SERVICE DIRECTIVE BULLETIN NO. 0103

1. SUBJECT: Inspection Of Turbocharger Bypass Tube
2. MODEL: F-28C and 280C
3. EFFECTIVITY: All serial numbers
4. BACKGROUND:

Figure 1

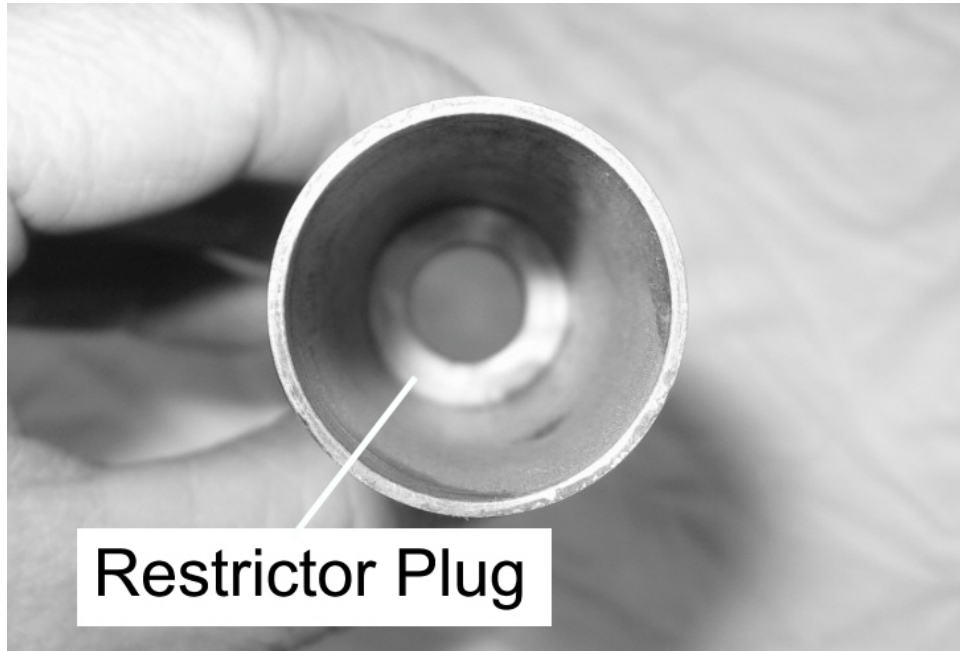
- A. Using an inspection mirror and suitable light source, inspect the bypass tube for the restrictor plug (Figure 1) via the exhaust tail pipe.
- B. If the bypass tube does not have the restrictor plug, replace the bypass tube with an airworthy restrictor bypass tube, P/N 28-125017-1.

At or before the next 100 hour/annual inspection, inspect the bypass tube to determine if it is equipped with a restrictor plug. If the bypass tube does not have a restrictor plug, replace the bypass tube with an airworthy restrictor bypass tube, P/N 28-125017-1.
